BENTON-CAROLINA SUBDIVISION

Engineering Comments: FINAL PLAT COMMENTS (should be addressed prior to submitting the FINAL PLAT for acceptance and signature by the City Engineer):

APPLICATION NUMBER 2 DATE January 23, 2020

DETAIL SITE PLAN

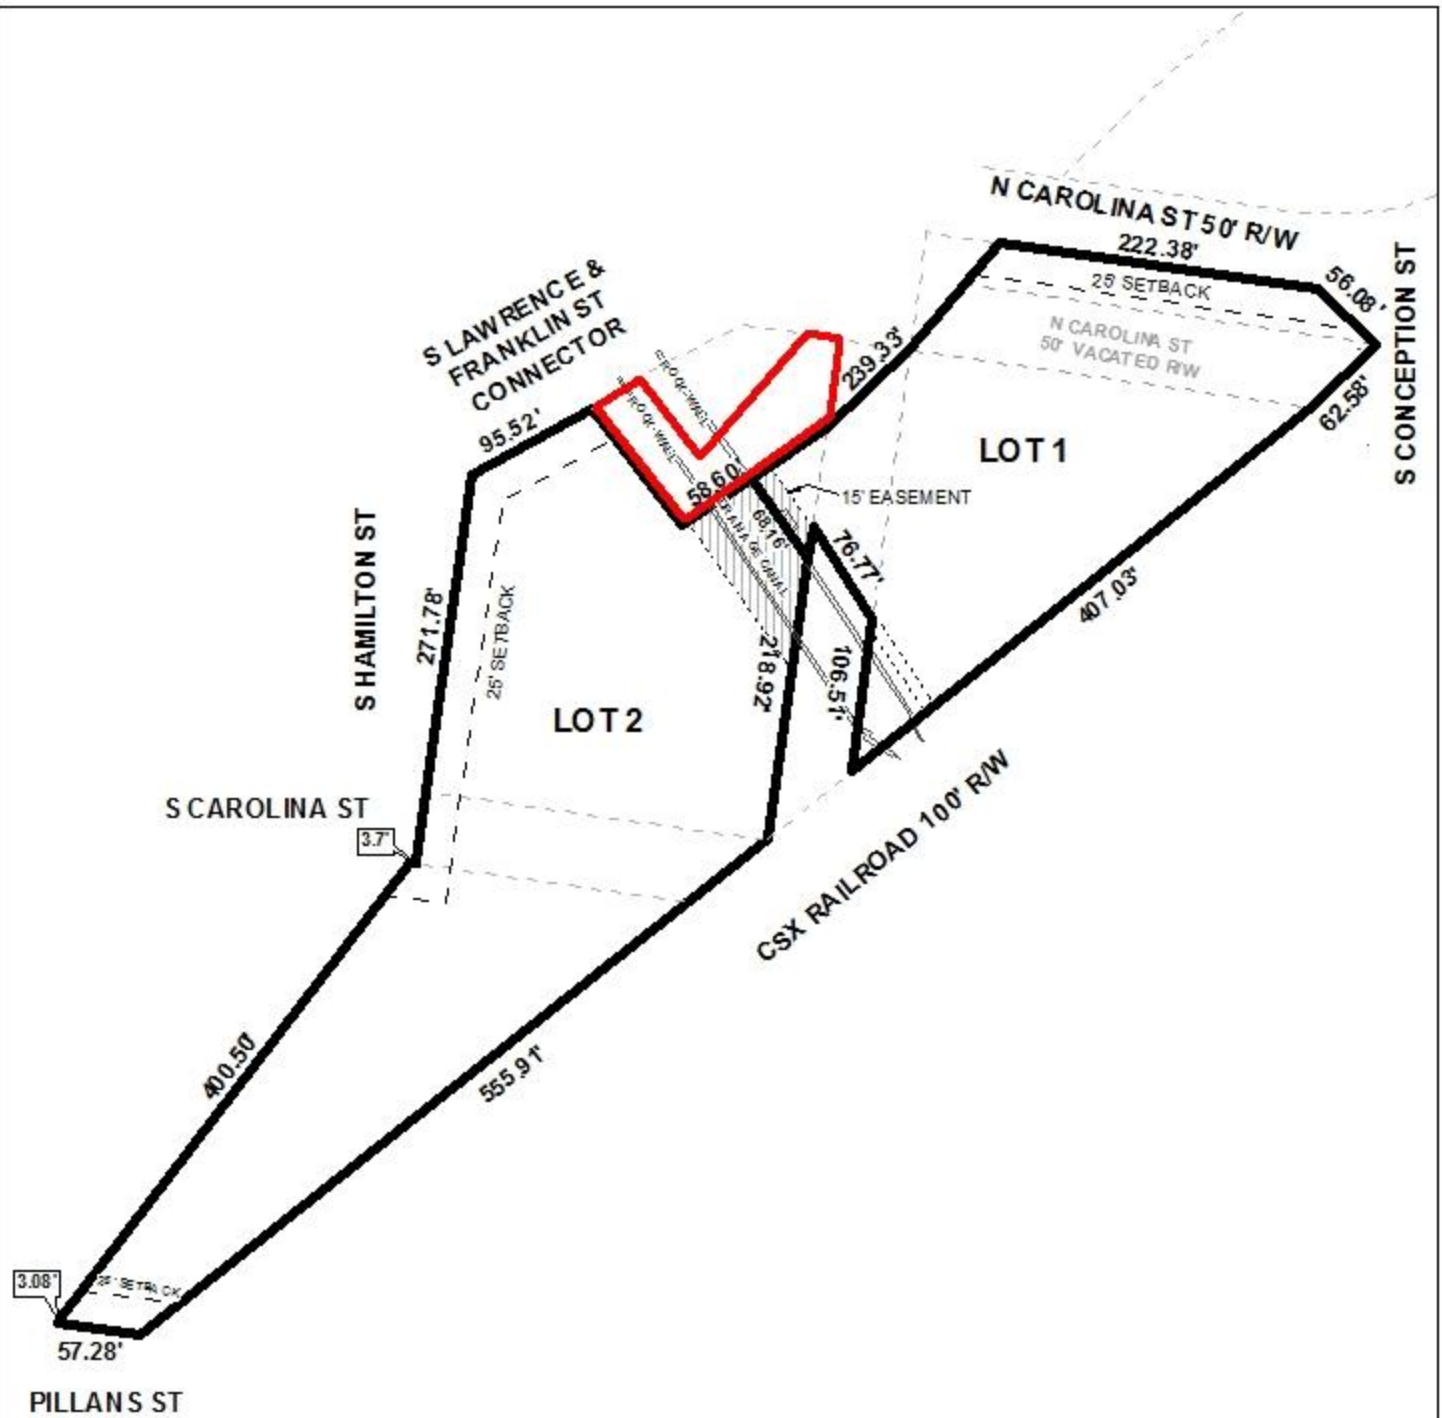
- B. Provide and label the monument set or found at each subdivision corner. Five (5) of the corners are not labeled.
- C. The first part of the Legal Description contains reference to parcels contained in part of proposed LOT 1 but does not have any reference to the parcels shown in proposed LOT 2.

- D. Show and label all flood zones.
- E. Show and label the MFFE (Minimum Finished Floor Elevation) on each lot that contains an AE, V, or X (shaded) flood zone designation.

- F. GIS indicates that there is a drainage easement that covers a large portion of proposed LOT 1.
- G. Revise the proposed Drainage Easement dedication to begin at the lot corner (58.60' from the northern common boundary corner with proposed LOT 1). Coordinate with Engineering Dept. as necessary.

The proposed plat illustrates a compliant right-of-way width for North Carolina Street however; it does not provide the current right-of-way widths for the remaining five (5) streets. At this location, previously approved and recorded plats illustrated the following: a 60-foot right-of-way width along South Lawrence and Franklin Street Connector; a 50-foot right-of-way width each for South Hamilton Street, South Carolina Street, and Pillians Street; and a 64-foot right-of-way width along South Conception Street. Taking these into account, City GIS data suggests a potential need for dedication along South Conception Street, South Lawrence and Franklin Street Connector, and Pillians Street. If approved, the Final Plat should be revised to illustrate compliant right-of-way widths measured from the center lines of South Conception Street, Pillians Street, South Carolina Street, South Hamilton Street, and South Lawrence and Franklin Street Connector, adjusting for any required dedication as needed. In addition, the revision of minimum building setback lines adjusted for dedication will be required.

The proposed plat does not seem to indicate compliant radius curves at the Southwest corner of South Conception Street and North Carolina Street or at the Southeast corner of South Hamilton Street and South Lawrence and Franklin Street Connector. As such, if approved, the Final Plat should be revised to illustrate the dedication of each corner radius in compliance with Section V.D.6. of the Subdivision Regulations.

The lot size labels in both square feet and acres should be retained on the Final Plat, or a table should be furnished on the Final Plat providing the same information, adjusted for dedication as needed. Additionally, the instrument number and note regarding the vacated portions of South Franklin Street and North Carolina Street should be retained on the Final Plat, if approved.

Finally, it should be noted that a portion of one of the parcels (R022910370002006) included in the application is not entirely depicted on the preliminary plat. Therefore, the preliminary plat should be revised to include the entirety of all parcels.

- 1) revision of the preliminary plat to include the entirety of all parcels, to include additional labels and fees, as appropriate.
